# P & D ENVIRONMENTAL

January 17, 2005  
Work Plan 0330.W2A

**SUBJECT: SUBSURFACE INVESTIGATION WORK PLAN (B8 Through B12)  
ADDENDUM  
ACEHS File # RO0002509  
901 77<sup>th</sup> Avenue  
Oakland, California**

**SITE PLAN**

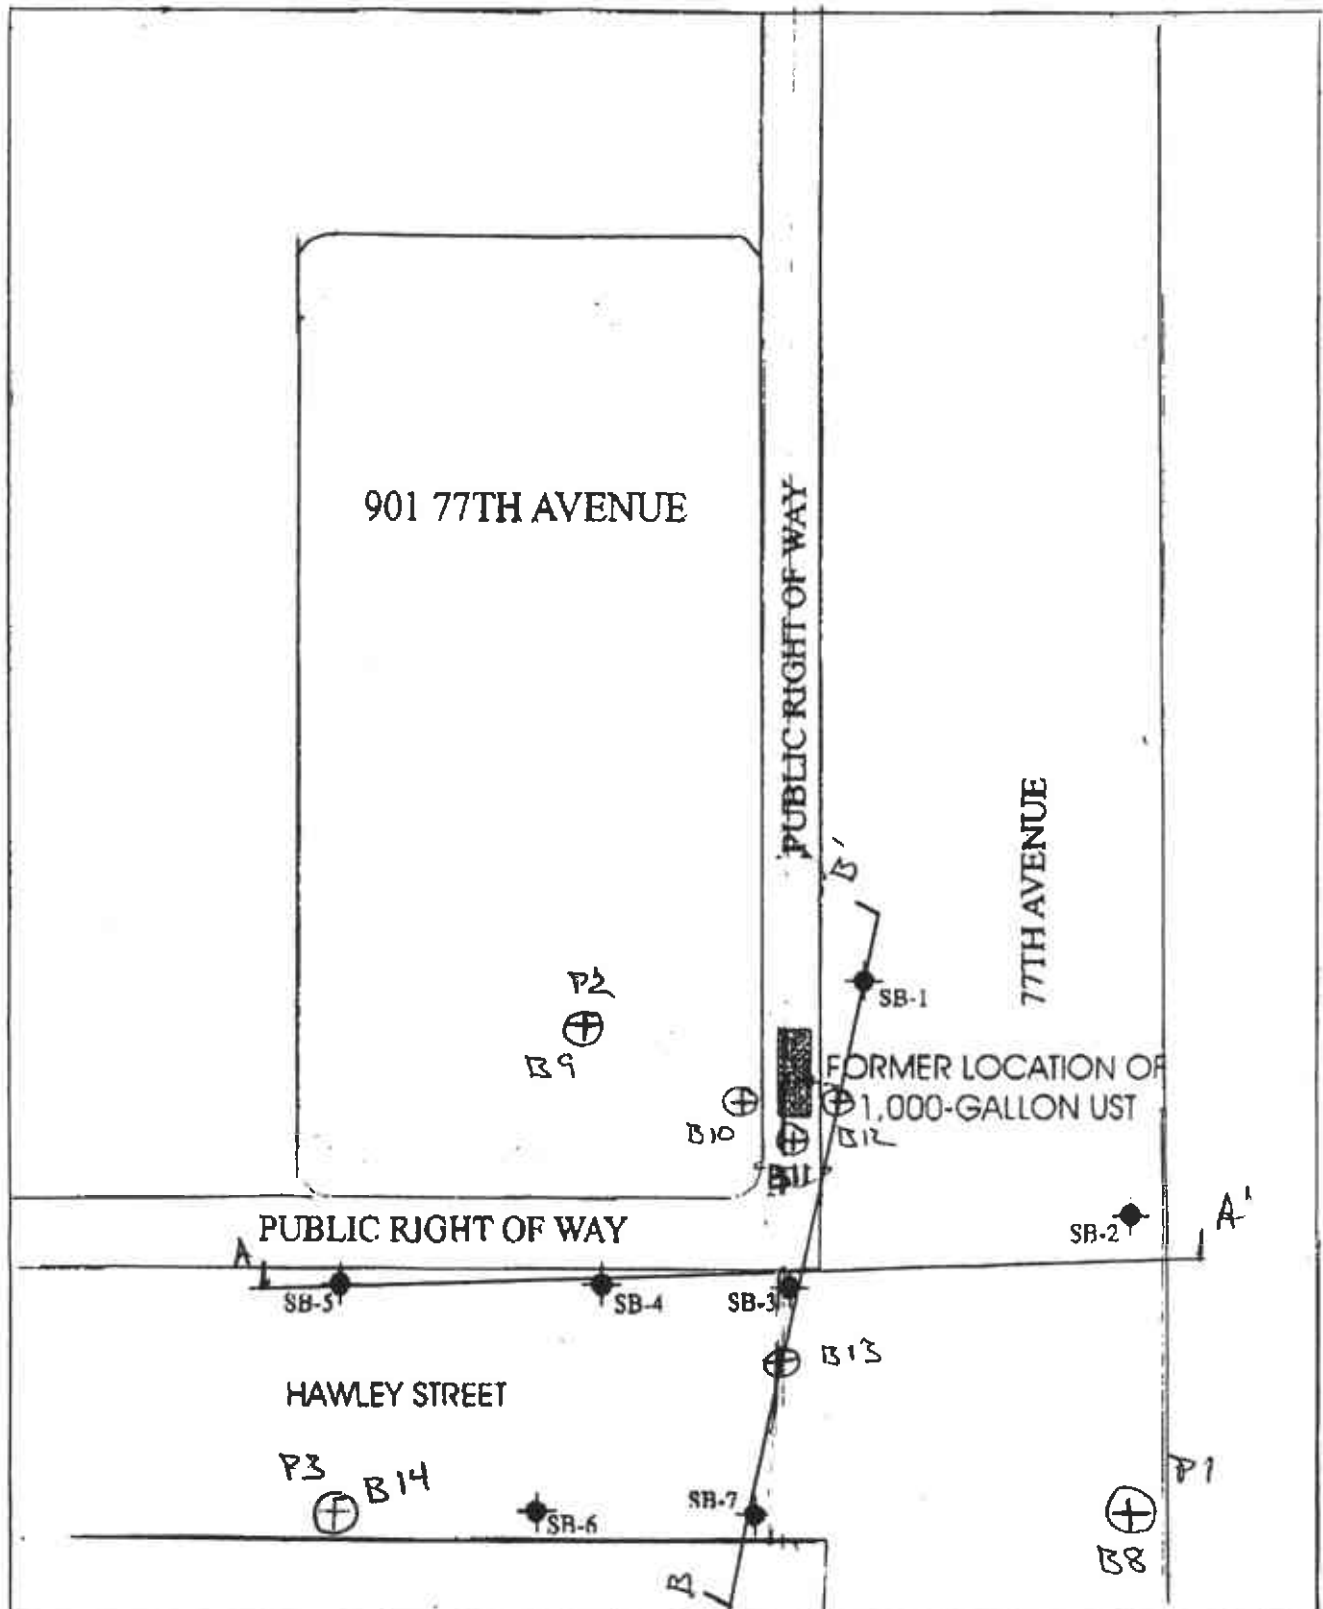
- 1) In boreholes B8 and B9 collect discrete soil and groundwater samples from immediately below the water table and at a depth of 10 feet below the water table.
- 2) In boreholes B10, B11 and B12 collect discrete soil and groundwater samples from immediately below the water table and at depths of 10 and 20 feet below the water table.
- 3) Install one additional borehole designated as B13 at the location shown on the attached site plan. The borehole will be drilled using procedures identified in the

October 26, 2004 Work Plan for boreholes B10, B11 and B12. In addition, at the time of drilling of B13, collect discrete soil and groundwater samples from immediately below the water table and at depths of 10 and 20 feet below the water table.

- 4) Install one additional borehole designated as B14 at the location shown on the attached site plan. The borehole will be drilled using procedures identified in the October 26, 2004 Work Plan for boreholes B8 and B9. In addition, at the time of drilling of B14, collect discrete soil and groundwater samples from immediately below the water table and at depths of 10 and 20 feet below the water table.

- 11) Prepare geologic cross sections A-A' and B-B' at locations shown on the attached Site Plan and include the geologic cross sections in the report documenting the subsurface investigation.
